RPA STAFF RECOMMENDATION

Subdivision Case Number:	2016-042	PC Meeting Date: 08-08-16
Subdivision Name:	Eagle Bluff Woods Subdivision Lots 1 thru 24	
Applicant Request:	Final Plat	
Property Location:	7200 Block River Run Drive	
Property Owner:	Dr. Gangavaru	
Applicant:	Copp Engineering Group	
Total Acreage:	17.59 Acres	
Proposed Density:	1.36 dwelling units per acre	
Tax Map Number:	102I-D-006	
Zoning:	R2-A Rural Residential District	
Staff Recommendation:	<p>APPROVE as a Final Plat subject to the following conditions:</p> <ol style="list-style-type: none"> 1. Installation and completion of all required infrastructure related improvements as part of this subdivision development. 2. Submittal of all required infrastructure “as-builts” to the appropriate departments.

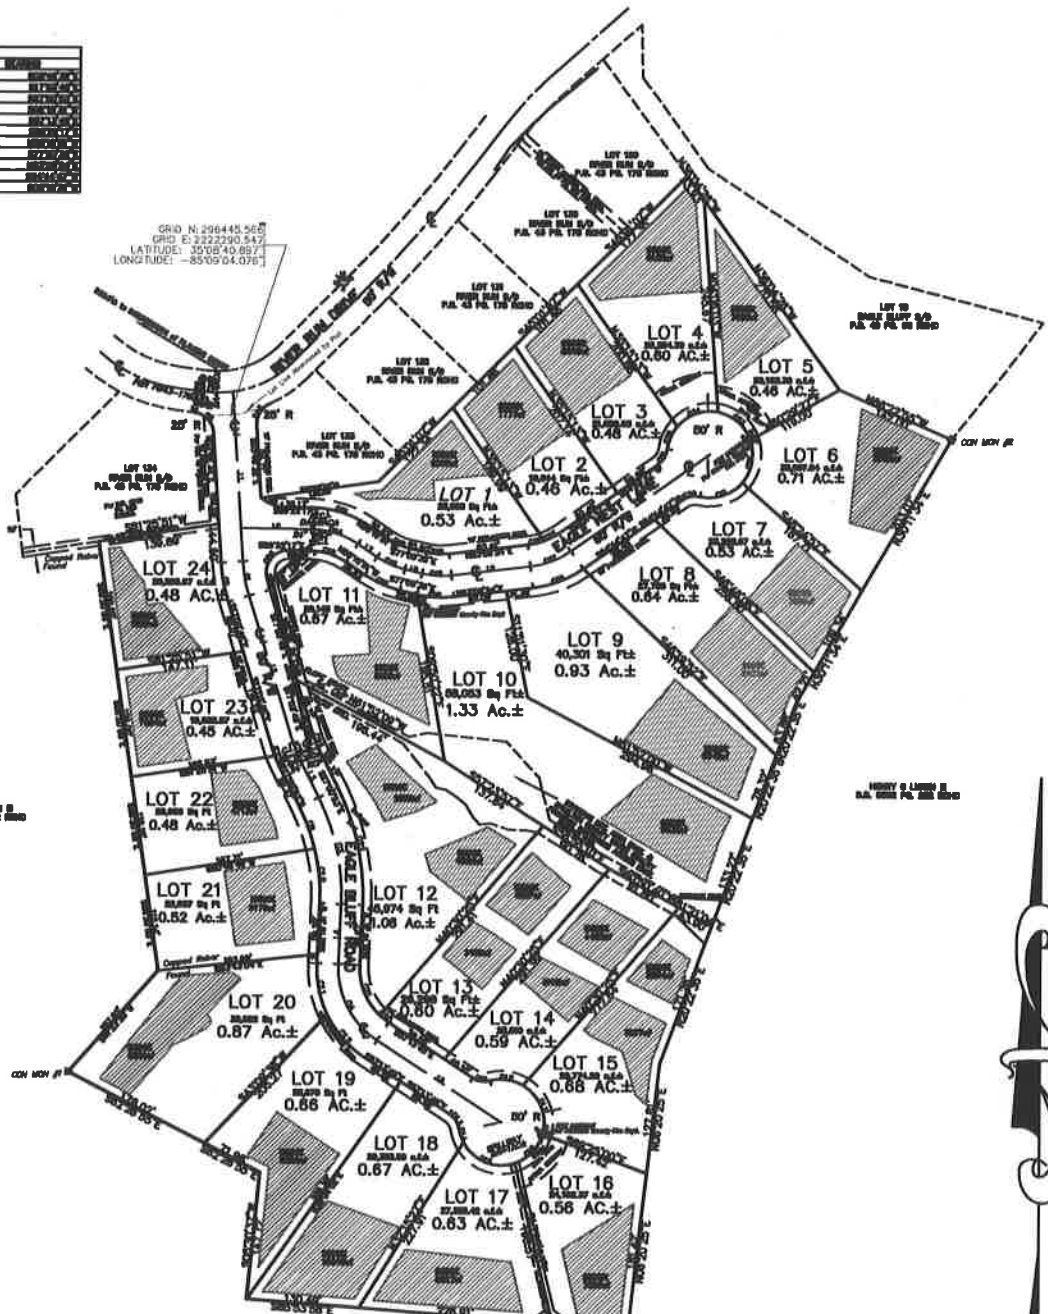
1. Sanitary sewers are not available. Submit plans to the Hamilton County Groundwater Protection for review and approval of septic tanks on the property.
2. Questions concerning Hamilton County Groundwater Protection comments and notes contact Hamilton County Groundwater Protection.

1. Add street addresses. Hamilton County GIS will assign street addresses after the Final Plat is approved by the Chattanooga-Hamilton County Regional Planning Commission.
2. Prior to Hamilton County GIS signing the Final Plat please submit the Geo-referenced CAD drawing used to create this subdivision plat. If GIS doesn't receive a copy of the Geo-referenced CAD drawing file GIS will not sign the Final Plat.
3. Questions concerning Hamilton County GIS comments and notes please contact GIS at (423) 209-7760.
